Product Support Bulletin 2004-002

- SUBJECT: Propel Disable Kit 98510026
- RATING:

MACHINE MODEL(S): NETP Chemical Tie Plugger

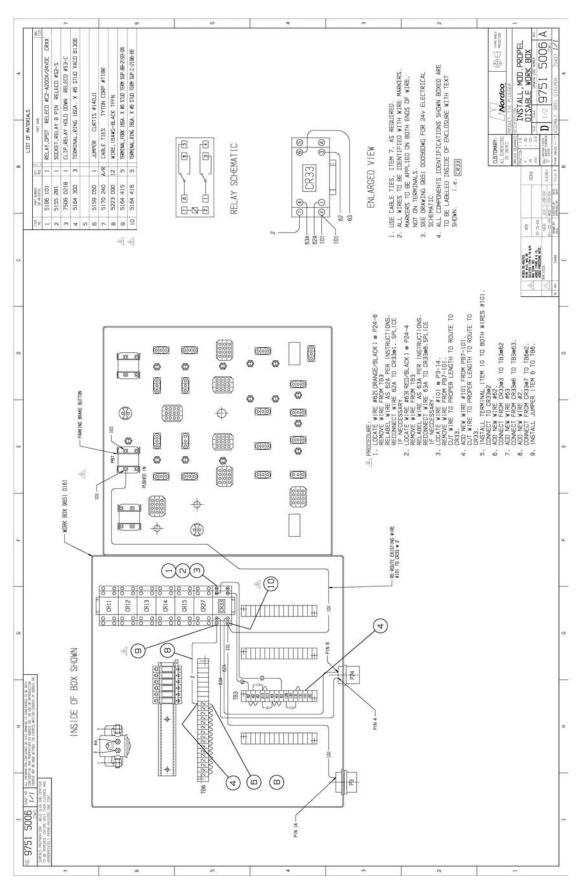
SUMMARY: Installation of Propel Disable Kit to prevent accidental machine movement.

- **OPERATIONAL IMPACT:** This kit adds a relay, CR33, to the propelling foot pedal circuit to interrupt the power to the Propel Valve when the Electrical Interlock Button is pushed in. This will prevent the Propel Valve from being energized and will help prevent movement of the machine if the parking brake does not hold properly.
- ACTION: The kit consists of a DPDT Relay p/n 5196101, a Relay Socket p/n 5155281, a Relay Mounting Rail p/n 81941160, wire, hardware and installation instructions. This kit can be installed with basic hand tools in about an hour. See the installation instructions on Page 2.
